**Bridge Portables Program  
LODI UNIFIED SCHOOL DISTRICT**

**ADDENDUM #1**

PROJECT: Bridge Classroom Portable at Lawrence ES  
Lodi Unified School District

DATE : December 3, 2025

C1.1

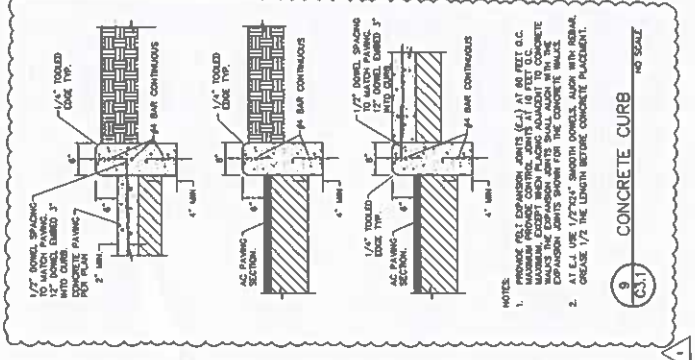
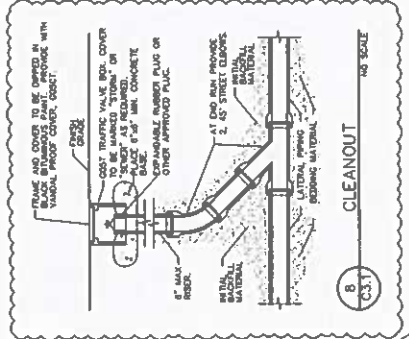
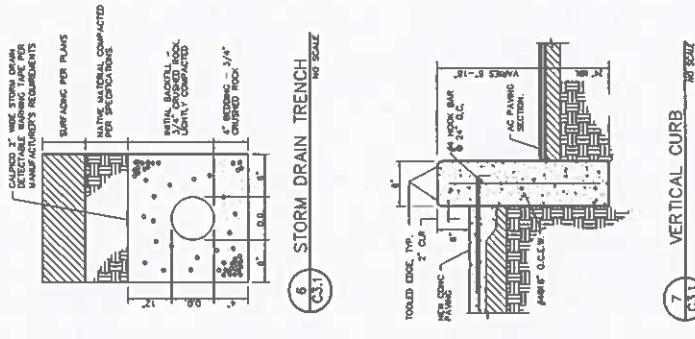
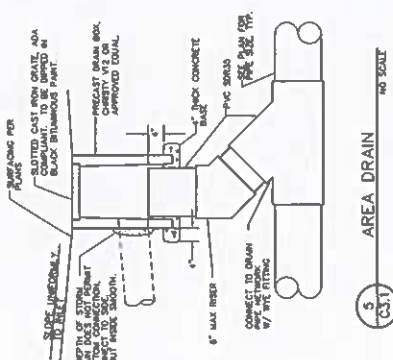
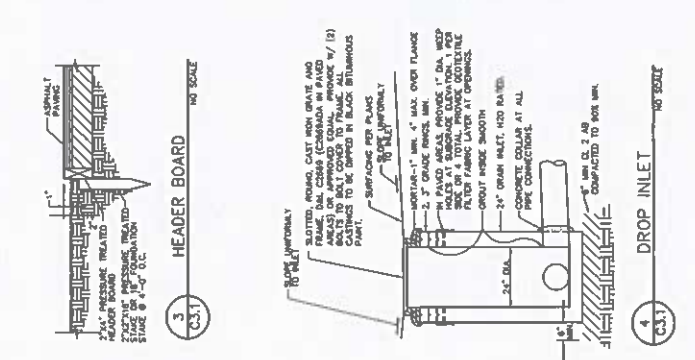
The Bridge Portable Classroom building at Lawrence Elementary School has been shifted 5'-2" east to accommodate the placement of a relocated portable classroom building (DSA #02-123755). Refer to sheets G1.1, G1.2, C1.1, C2.1, C3.1, AA1.1, and AA1.2, for the revised location of the Bridge Portable Classroom Building and associated work.

1-ES1.2

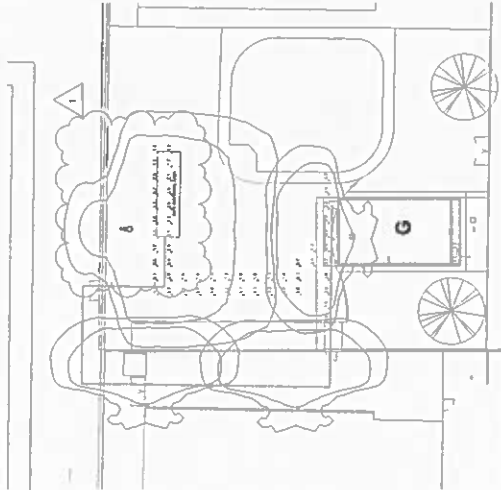
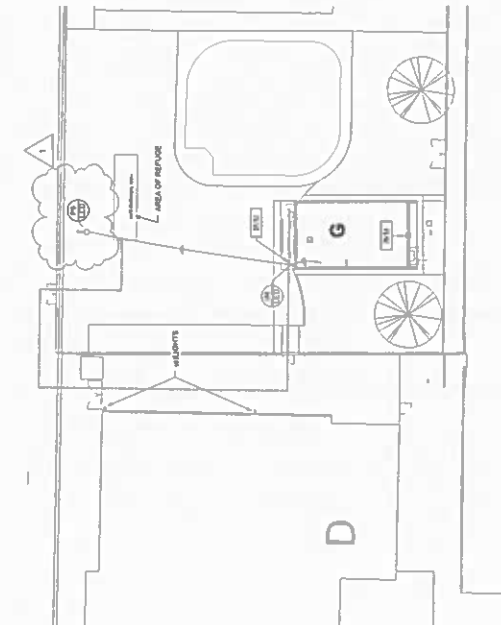
Refer to sheets AA1.2 and 1-ES1.2 for the revised location of the new light pole. The new light pole is relocated south of the fence line adjacent to the safe dispersal area.
